3.1 CAD CALCULATIONS CURRENT MODIFICATION AREAS

DEPARTMENT ITEM 3.2:

DEPARTMENT ITEM 4.1:

3.2 COMMUNAL AND PUBLIC OPEN SPACE DETAILS

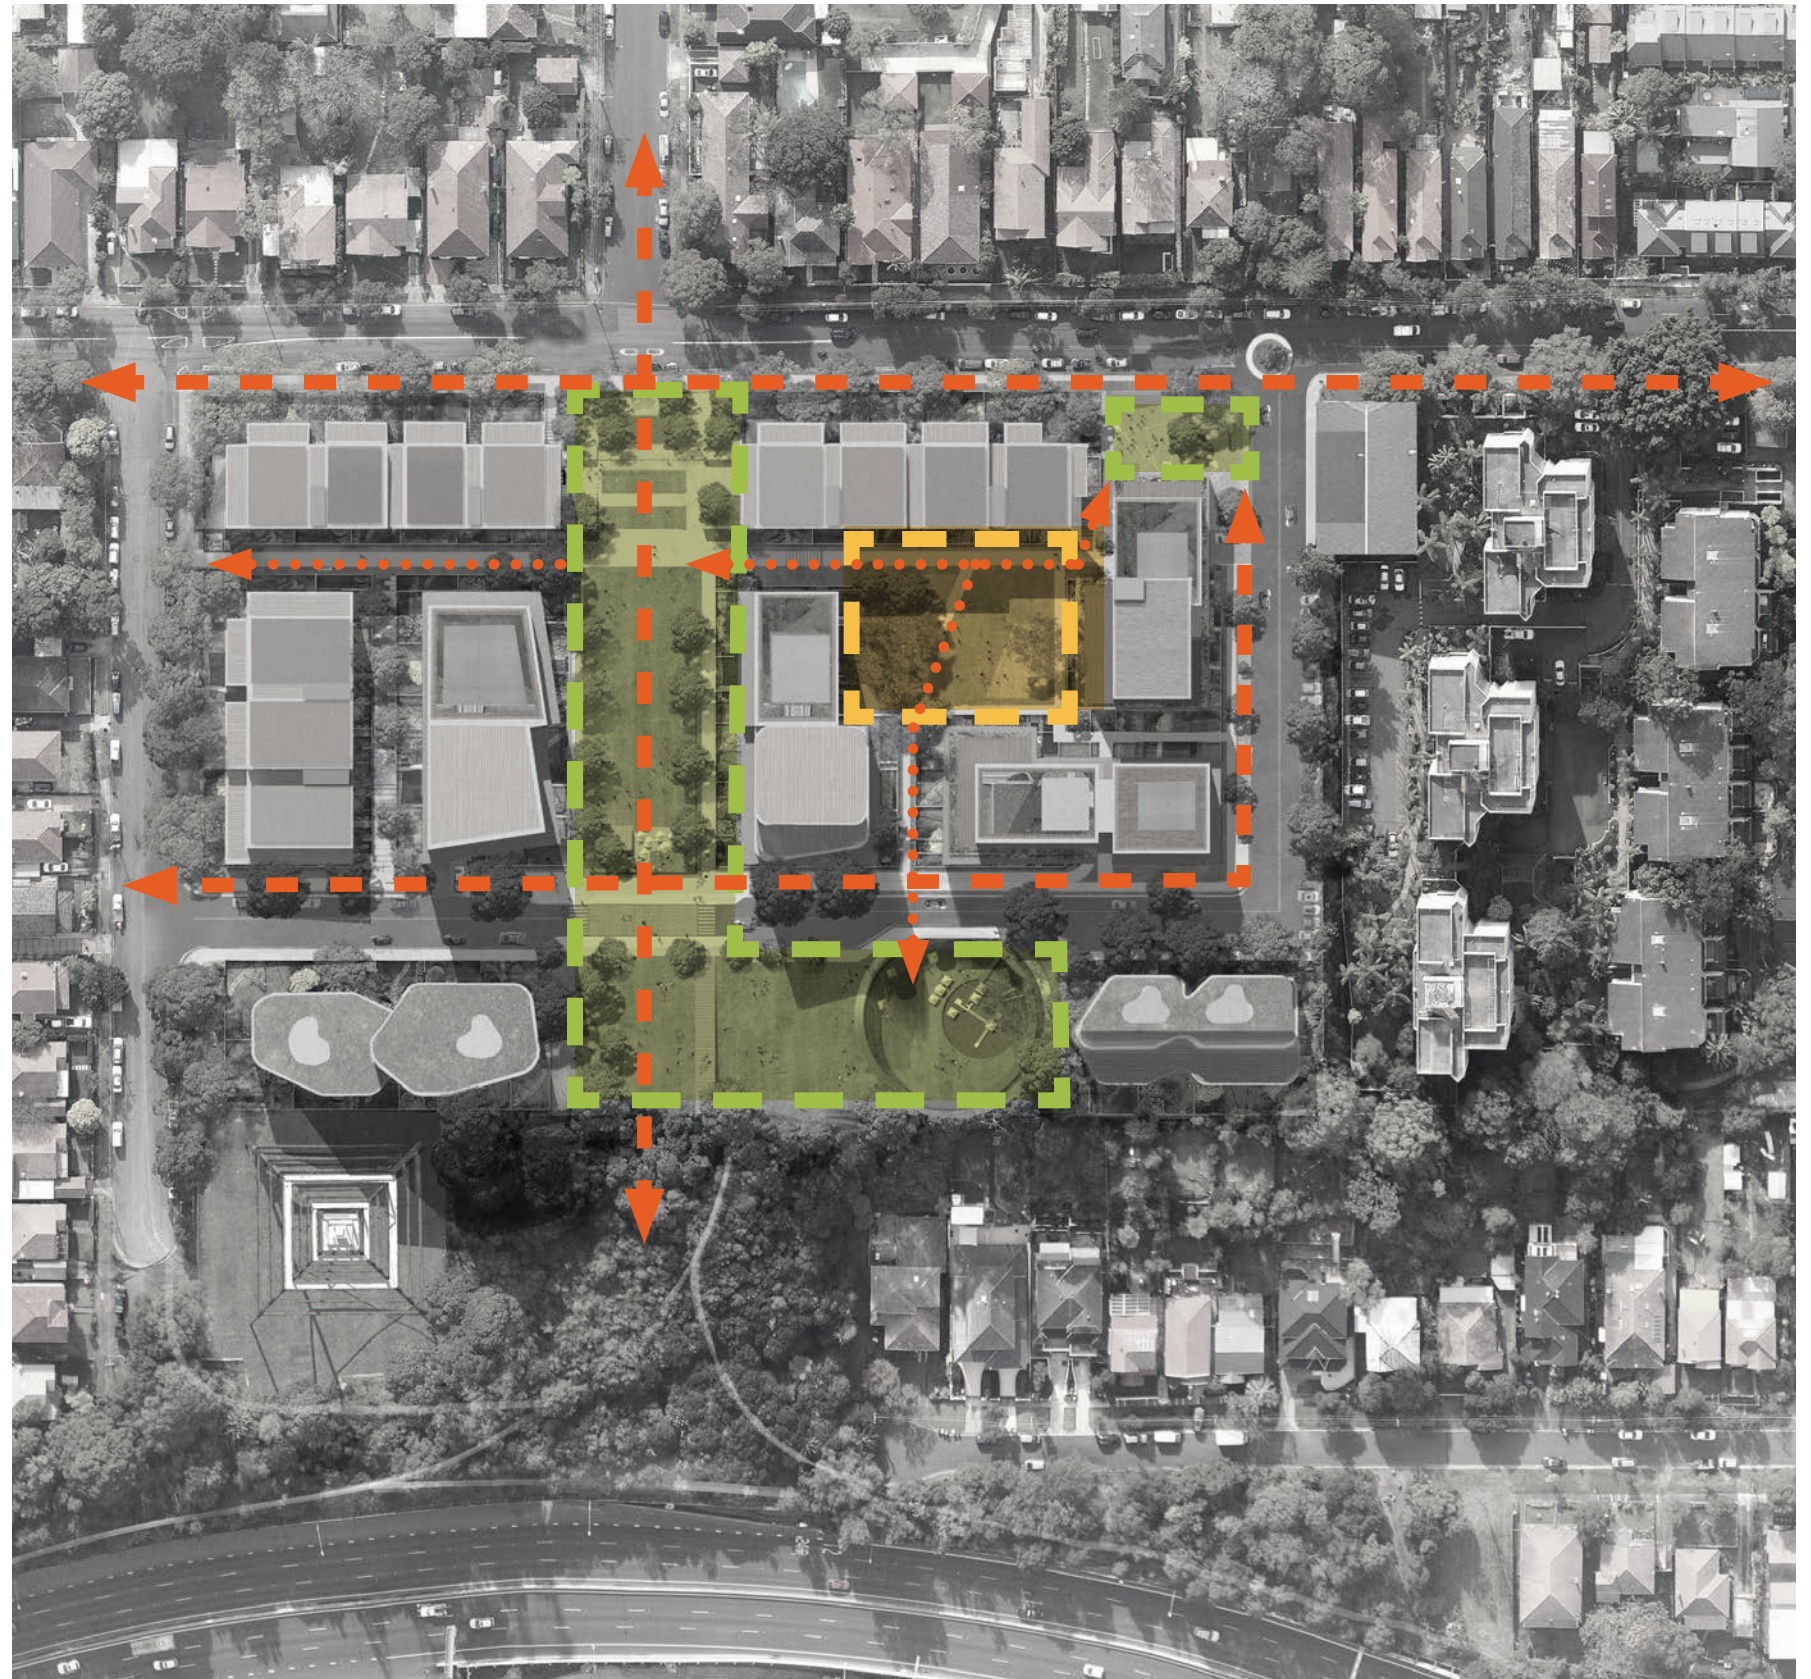
“Further additional information is required to demonstrate how the proposed public and communal open spaces will be delineated, with the provision of equitable access, hard and soft landscaping, clearly visible and safe pedestrian access points, way finding, commercial facilities (non-residential floor space) or other public infrastructure.”

A key concept of the masterplan are clearly legible and easily accessible public and communal open spaces throughout the site. Importantly, whilst the masterplan establishes strong design fundamentals, the detailed execution will be the subject of assessment as part of future detailed applications for development.

The arrangement of the public spaces are designed to address Artarmon Road and provide wide open frontages to the surrounding neighbourhood. The Village Green is conceptualised as an extension of Edward St which help to clearly identify these spaces as for public use. The communal open space is framed by 4 buildings with connections to each of the public open spaces. The more sheltered character of this area is further enhanced by keeping the established Tree 32 within this courtyard.

All areas are visible through clear sight lines from multiple areas on the ground as well as from the apartments, achieving high levels of security through passive surveillance. Wide spaces with multiple access points, no hidden corners or cul de sacs further add to the inherent security designed into the masterplan.

3.4 THE VILLAGE SQUARE

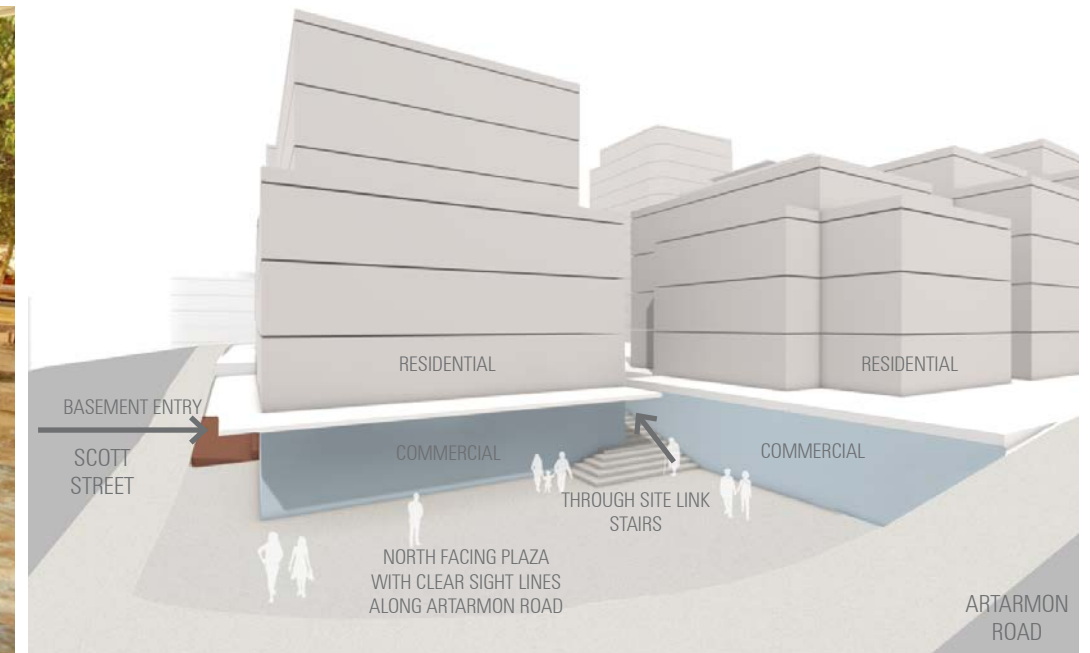
“Provide further details on the future use of the village square, including any future ground floor uses in Building B or G to activate this space.”

The site offers a Village Square located to the west of Scott St. framed by Scott St, Artarmon Road, ‘The Loft’ and small commercial frontage under Building B and G. Its position on Artarmon Rd ensures it gains northern solar access and is clearly visible to passing pedestrians and cars.

The Village Square will be enlivened by two active commercial frontages under building B and G. The space under building B is approx. 250m² whilst the space under building G is approx. 170m². Both spaces will support small scale commercial tenancies and have good connections to the basement for servicing, deliveries, waste and access.

The level of the Village Square sits flush with the existing level of Scott Street to ensure good accessibility. The square is sunken below the steep sloping Artarmon Road as it rises to the west.

4.1 BUILDING SEPARATIONS AND APARTMENT AMENITY

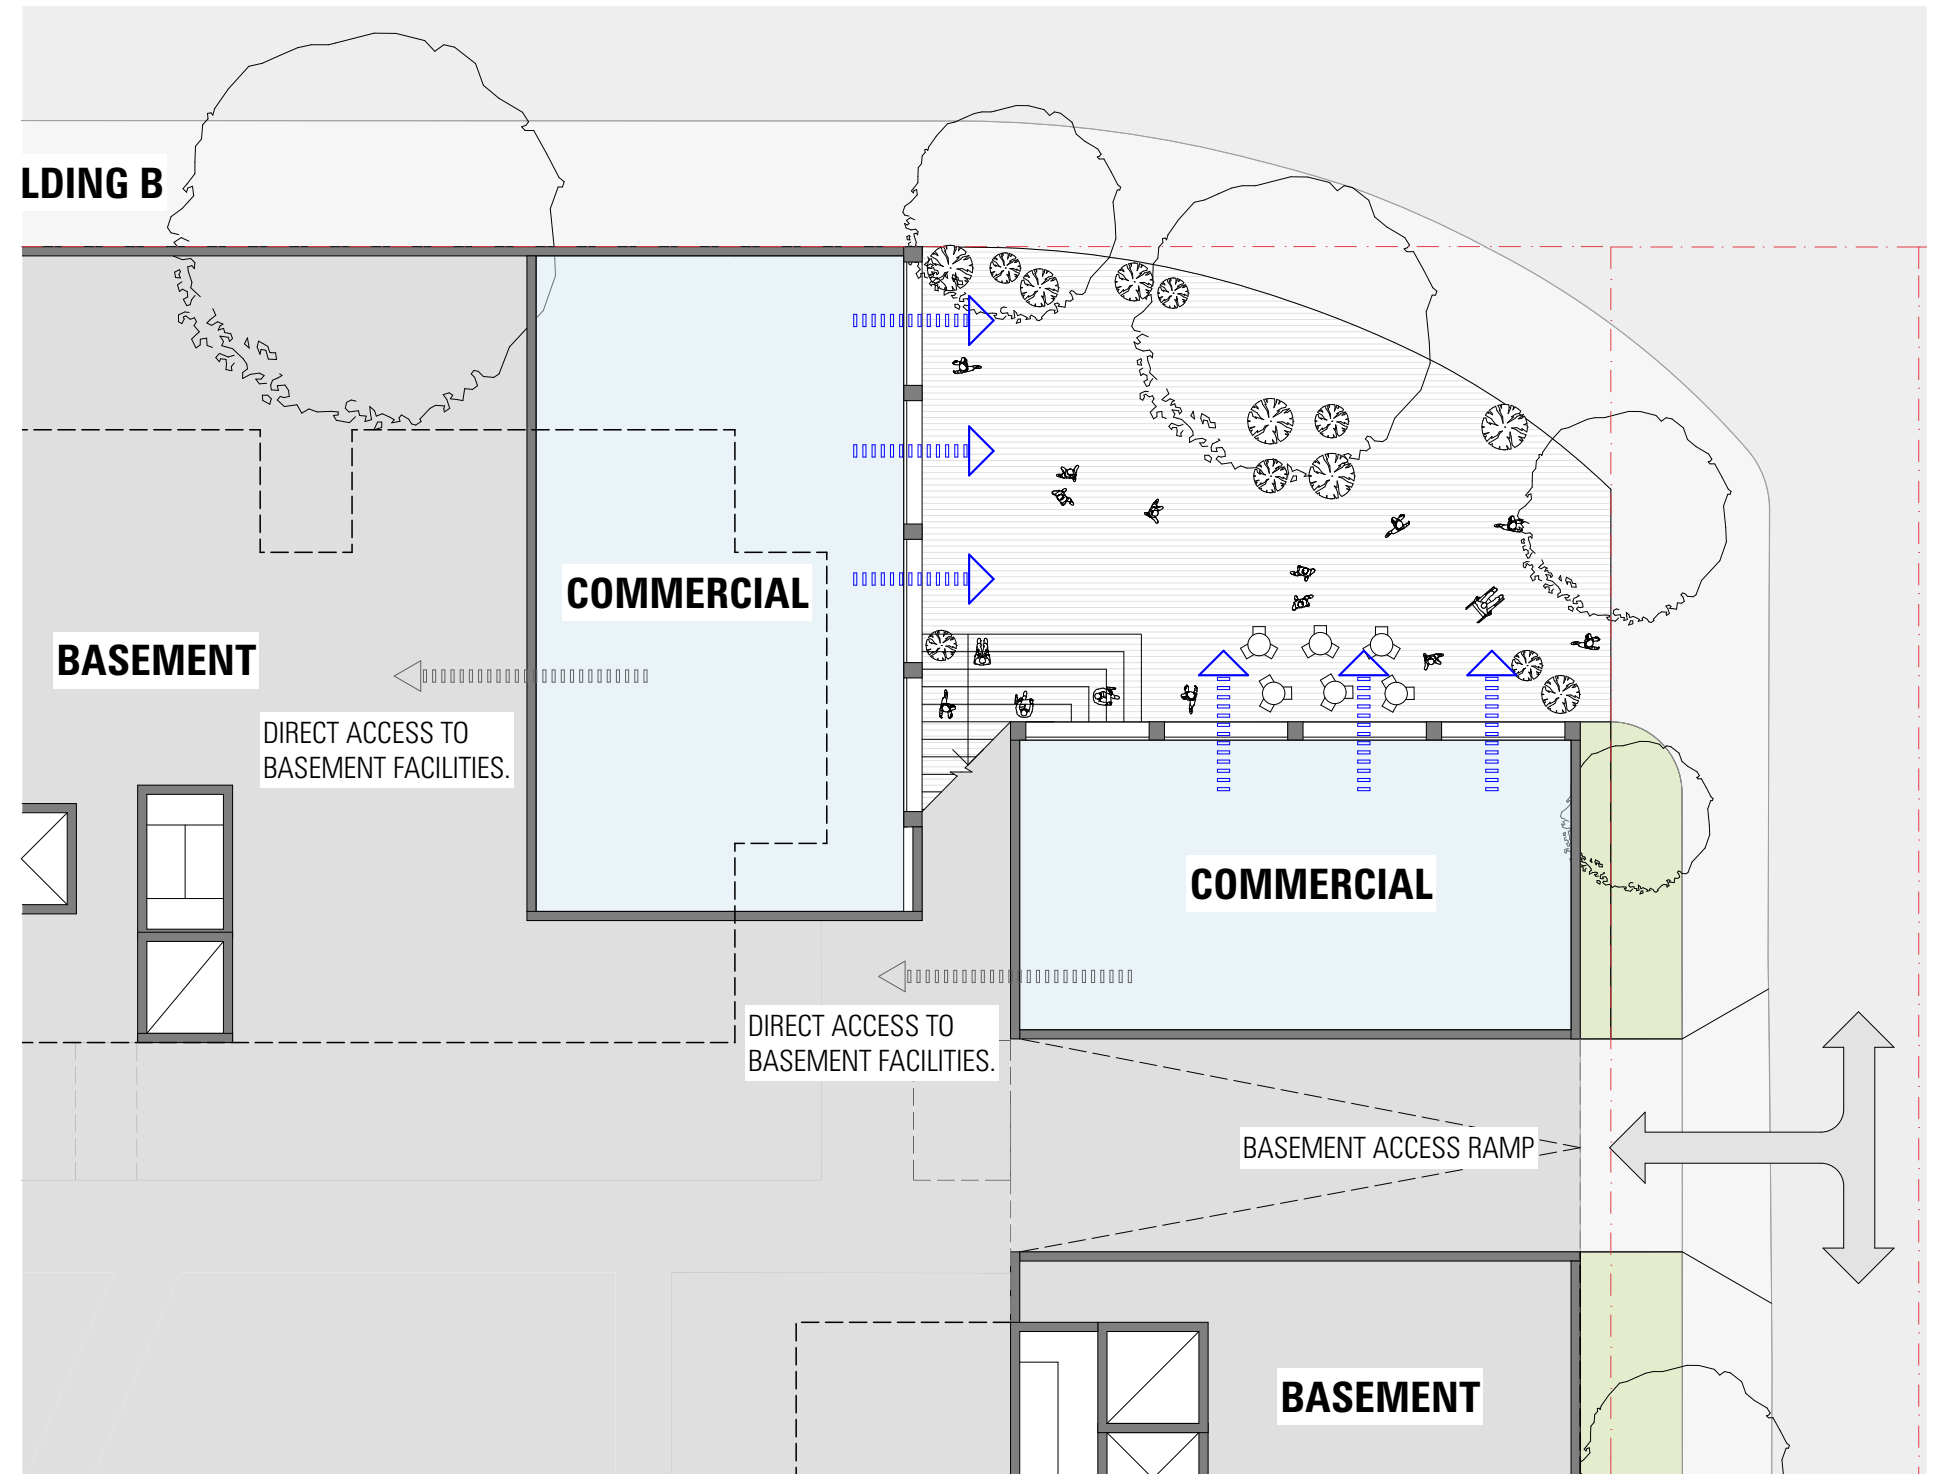
“Review the internal building separation having regard to the recommendation of the Apartment Design Guide and provide options to refine the envelopes to improve amenity for future dwellings, particularly between lower levels of Building B and G and all levels of G and F. ”

In reviewing the building separations, further small massing changes have been made to improve separations and residential amenity. Detailed plans have been prepared as a reference scheme to demonstrate high amenity for each apartment can be achieved.

Building separations have been updated in the architectural drawing set.

4.2 PRIVACY FOR UNITS TO GROUND FLOOR OF BUILDING B

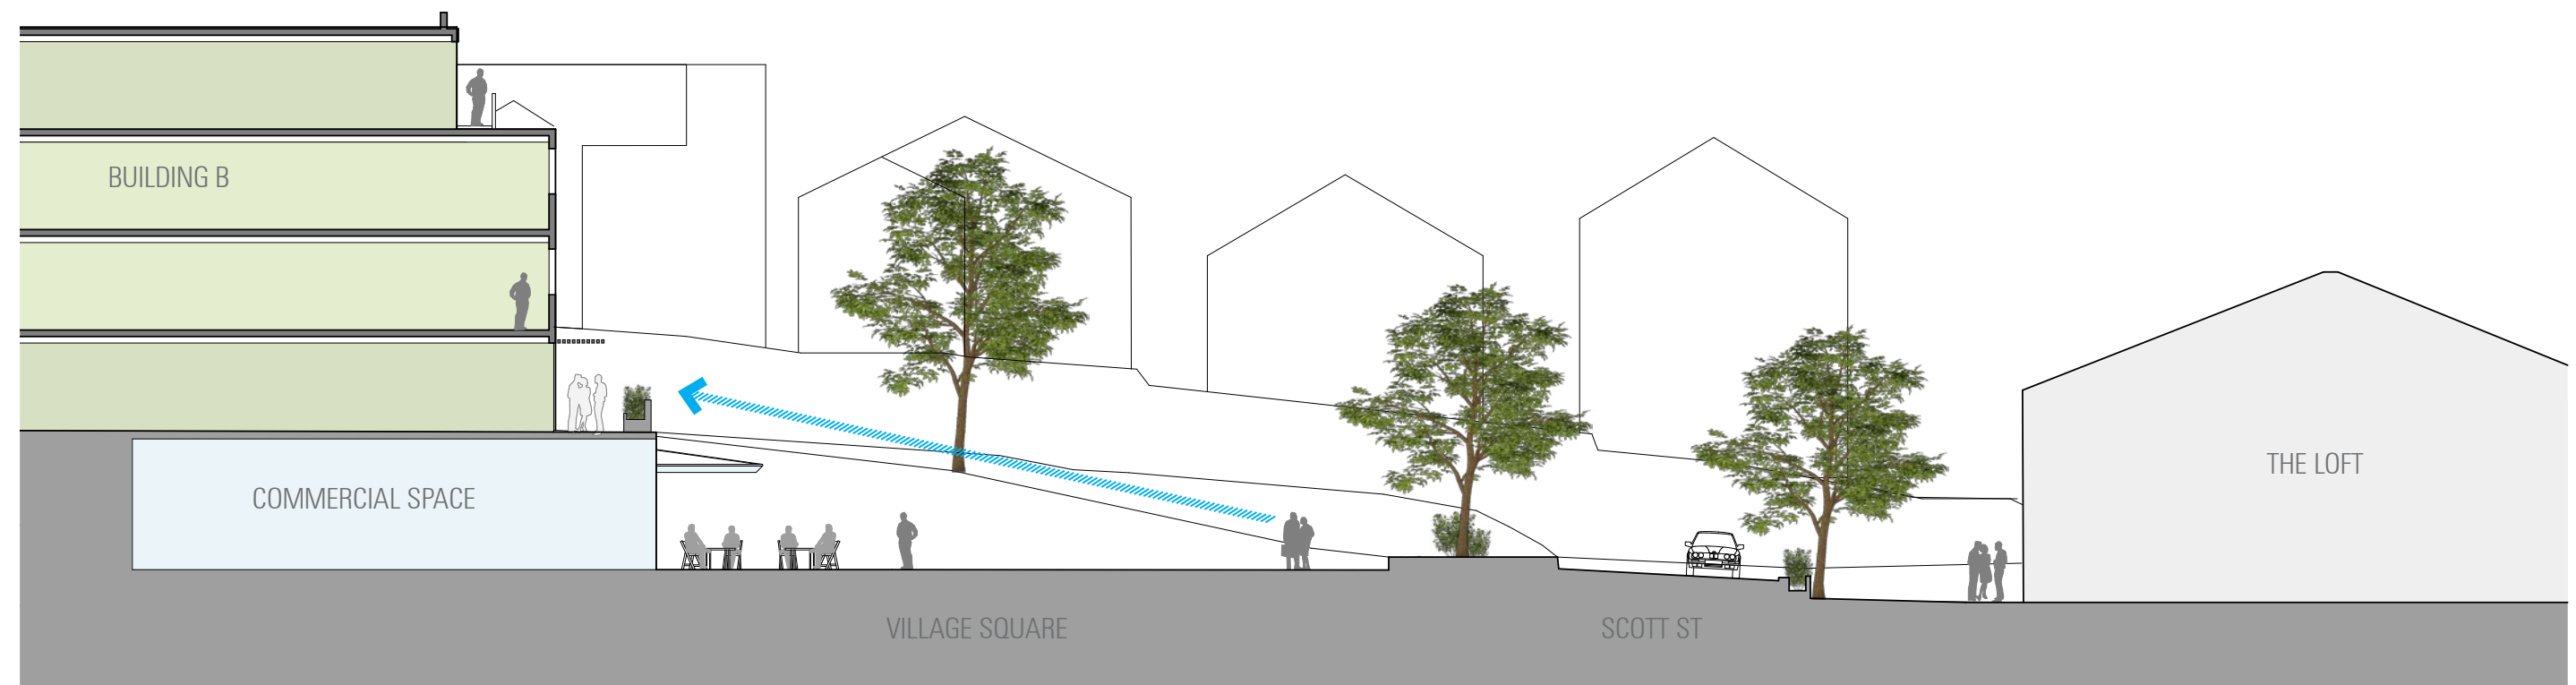
“Detail measures to achieve appropriate visual privacy and residential amenity for those dwellings adjacent to future public open space and the public domain.”

The following section demonstrates the relationship between the Village Square and Building B.

The apartment level, raised a full level above Village Square, will help to mitigate overlooking issues from the Village Square and will help separate the public realm from the private apartments.

The level separation between commercial and residential uses can be supported by future detailed design including the use of a commercial awning and planted balustrades. As seen in the reference layouts, the apartments have been designed in Building B to locate the primary living space towards Artarmon Road.
